5 open
5.70

UPGRADING January 31st 2008

From Jan 31st 2008, in agreement with the Group Finot Conq, it has been decided to bring the below modifications on Open 5.70 models :

PHILEAS BOATS OPEN 5.70
31.01.2008
BOOM VANG

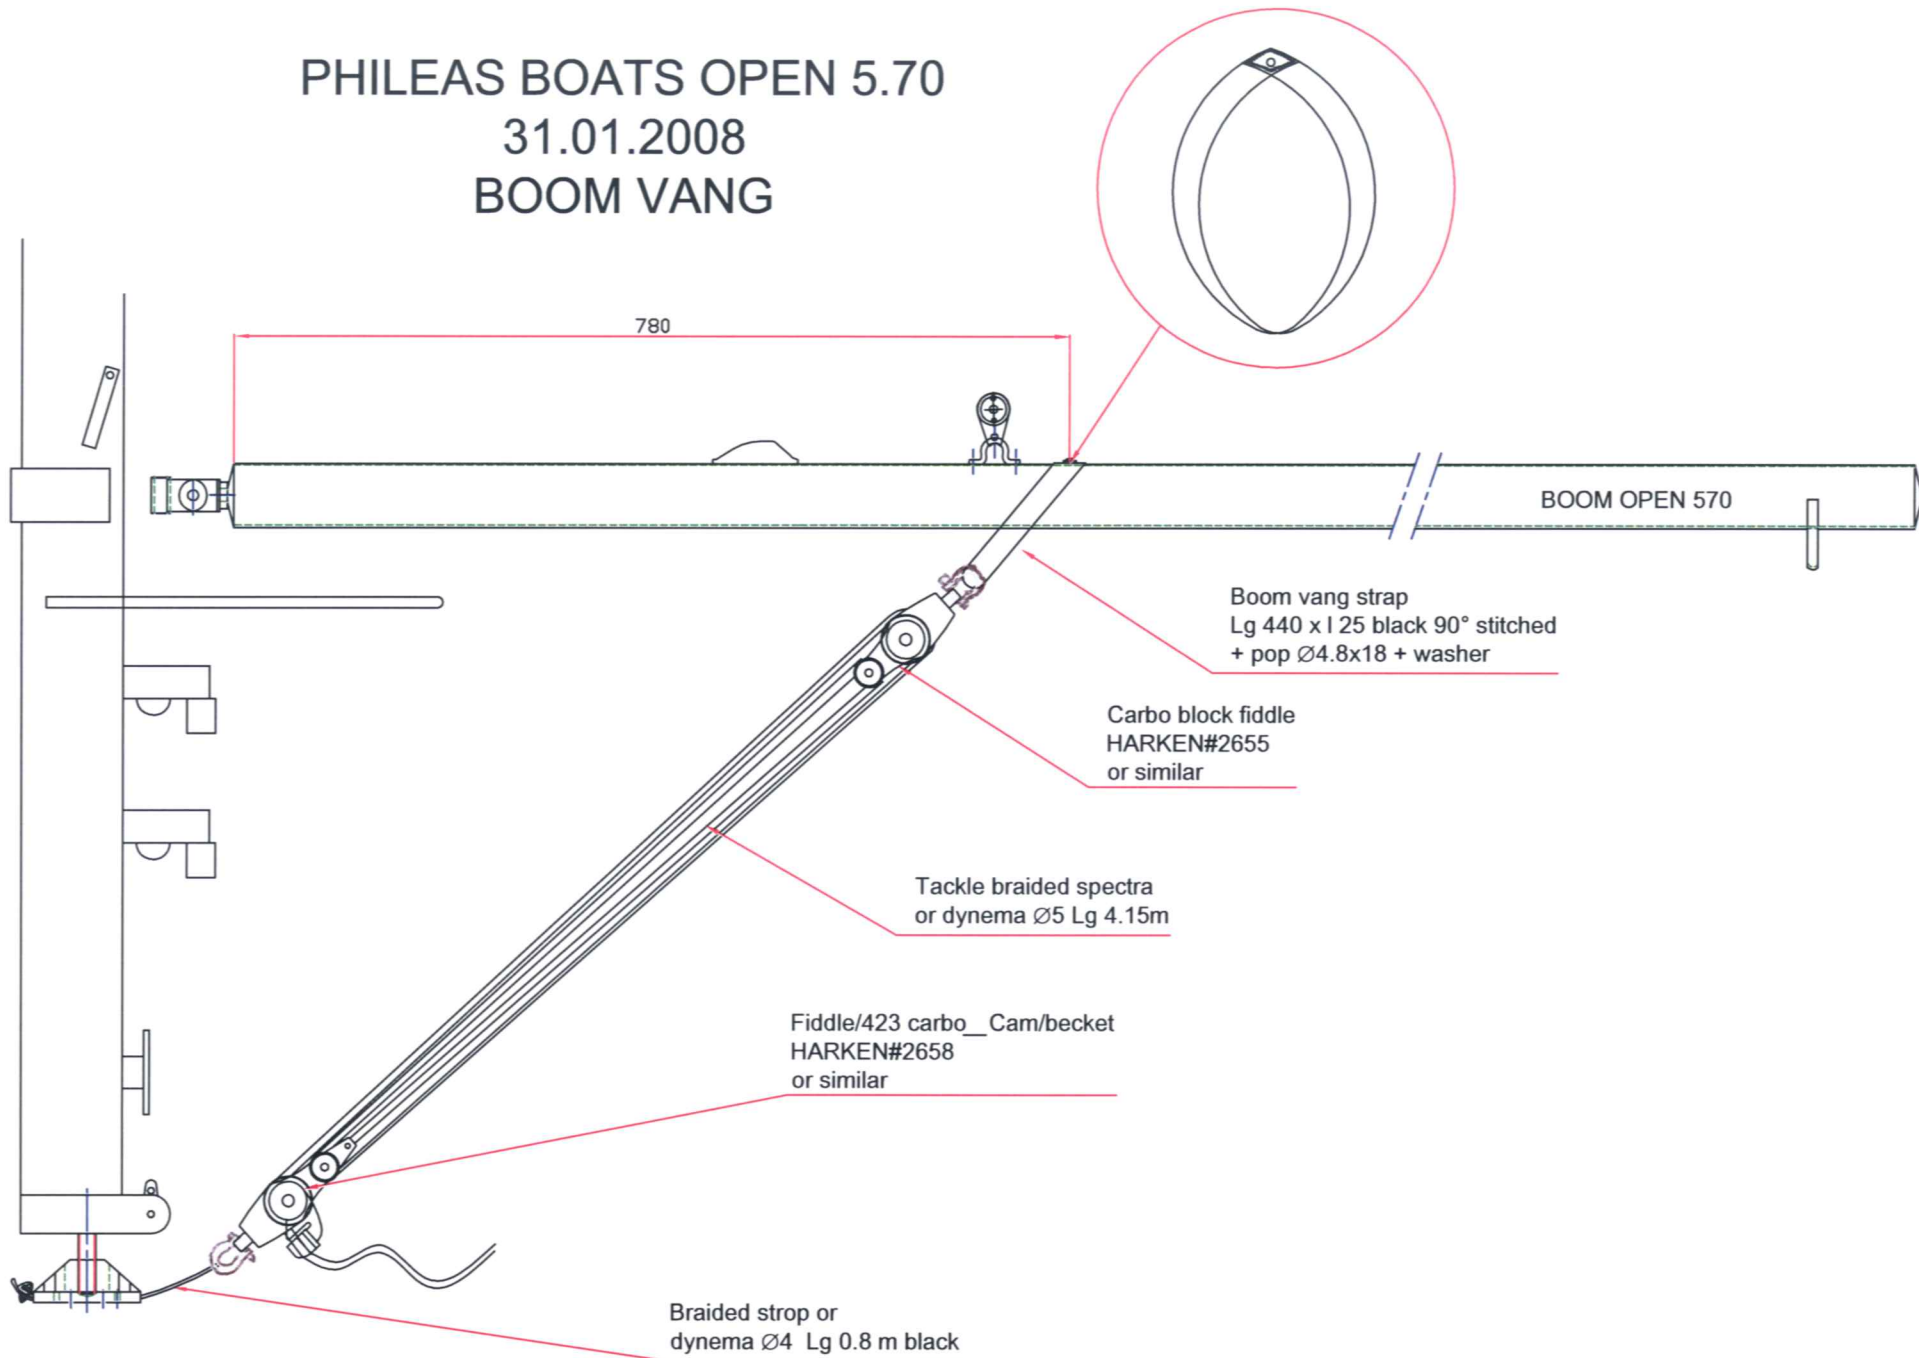
Open 5.70 are now supplied with a boom vang located as per attached sketch :

The boom vang is supplied complete with :

- 1 X stitched strap (L= 0,43 m l=25 mm) fastened to the boom thanks to a 5 mm diam. pop rivet and washer.
- 1 X fiddle /423 carbo-cam/becket HARKEN # 2658 or similar
- 1X carbo block fiddle HARKEN # 2655 or similar
- 1 X Spectra or Dynema diam 4mm L=0,8 m
- 1 X Spectra or Dynema diam 5mm L=4,15 m

No further modification will be authorised ; main purpose of the boom vang is to maintain the tension of the main sail leech before the wind (specially when sheet is firmly eased out , which is not recommanded).

All Open 5.70 supplied before January 31st 2008 have to be fitted with the described boom vang.
